# DEVELOPMENT REVIEW BOARD REPORT

**114-DR-2005**  
**Granite Reef Circle Lofts**

Request approval of a site plan and elevations for a new 3-building, 20-unit townhome development. The request also includes approval of landscape and lighting plans.

# **Stipulations for Case: Granite Reef Circle Lofts 114-DR-2005**

GRANITE REEF CIRCLE LOFTS  
ARCHITECTURAL SITE PLAN

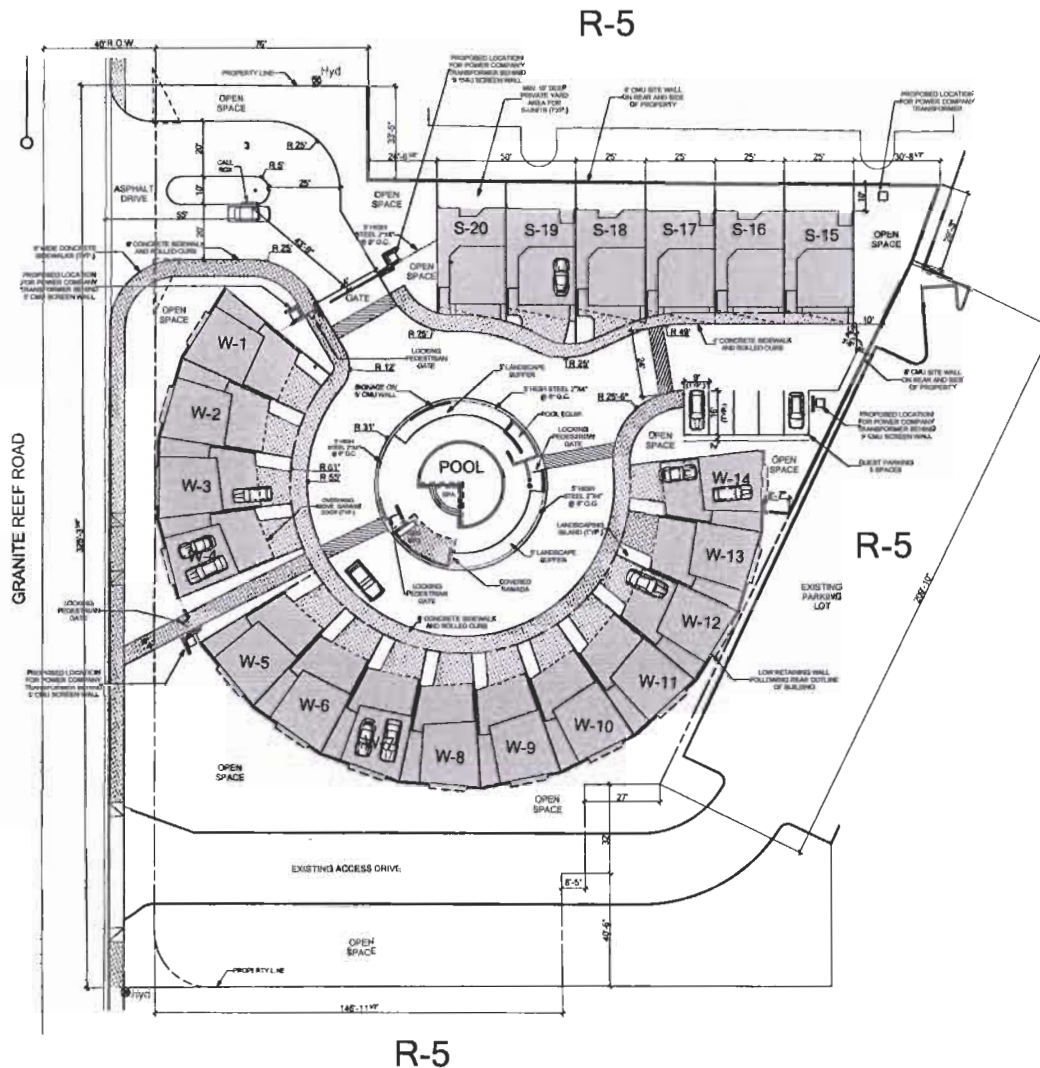
11. *The site plan shall be revised to show a minimum of two (2) accessible parking spaces, one of which must be van accessible. If applicant chooses to locate one or both of the spaces in the unit garages, the garages that are eligible to accommodate accessible parking shall be identified on the site plan, to the satisfaction of final plans staff.*
12. *The site plan shall be revised to show a minimum of three (3) top of curb elevations on Granite Reef Road.*

13. *The site plan worksheet shall be revised to reflect the correct ratio of private open space per unit, specifically for the "wedge" units, as required by the R-5 zoning ordinance, to the satisfaction of the Project Coordinator.*
14. *The site plan worksheet shall be revised to correctly identify the frontage open space area to the satisfaction of the Project Coordinator. Frontage open space shall not include landscape or patio areas along the rear of the property.*
